Project	IEEE 802.16 Broadband Wireless Access Working Group < http://ieee802.org/16 >	
Title	Corrections to definitions of Uplink MIMO in OFDMA PHY	
Date Submitted	2005-01-13	
Source(s)	Ran Yaniv, Tal Kaitz, Naftali Chayat, Vladimir Yanover, Danny Stopler Alvarion Ltd.	danny.stopler@alvarion.com ran.yaniv@alvarion.com tal.kaitz@alvarion.com
Re:	Call for comments, maintenance task group	
Abstract		
Purpose		
Notice	This document has been prepared to assist IEEE 802.16. It is offered as a basis for discussion and is not binding on the contributing individual(s) or organization(s). The material in this document is subject to change in form and content after further study. The contributor(s) reserve(s) the right to add, amend or withdraw material contained herein.	
Release	The contributor grants a free, irrevocable license to the IEEE to incorporate material contained in this contribution, and any modifications thereof, in the creation of an IEEE Standards publication; to copyright in the IEEE's name any IEEE Standards publication even though it may include portions of this contribution; and at the IEEE's sole discretion to permit others to reproduce in whole or in part the resulting I

Figure 249—UL STC tile

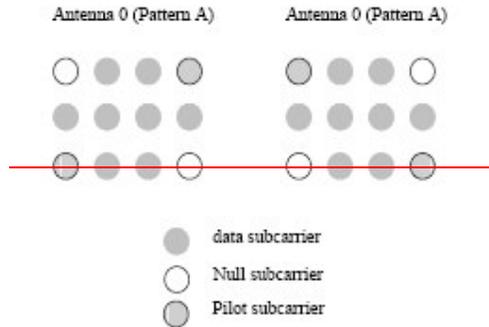
A user supporting transmission using STC configuration in the uplink, shall use a modified uplink tile. 2-transmit diversity ('STTD mode') data or 2-transmit spatial multiplexing ('SM mode') data can be mapped onto each subcarrier. The mandatory tile shall be modified to accommodate those configurations. [Figure 249 depicts the UL tile for STC transmission.](#)

Figure 249 – Mapping of data subcarriers in STTD mode.

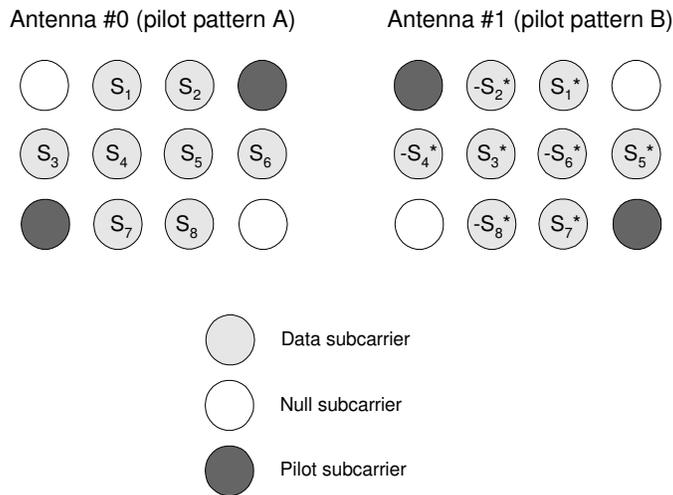
1. The data-subcarrier mapping scheme for UL STTD is not defined (8.4.8.1.5). Note that encoding subcarrier pairs across multiple tiles is not possible due to the existence of the subchannel rotation scheme.

1. Correct section 8.4.8.1.5: provide missing definition of STTD mode, define data subcarrier mapping in STTD mode.

[In STTD mode, the tiles shall be allocated to subchannels and the data subcarriers enumerated as defined in 8.4.6.2. The pilots in each tile shall be split between the two antennas and the data subcarriers shall be encoded in pairs after constellation mapping, as depicted in figure 249. The data subcarriers transmitted from Antenna #0 follow the original mapping defined in 8.4.6.2.](#)
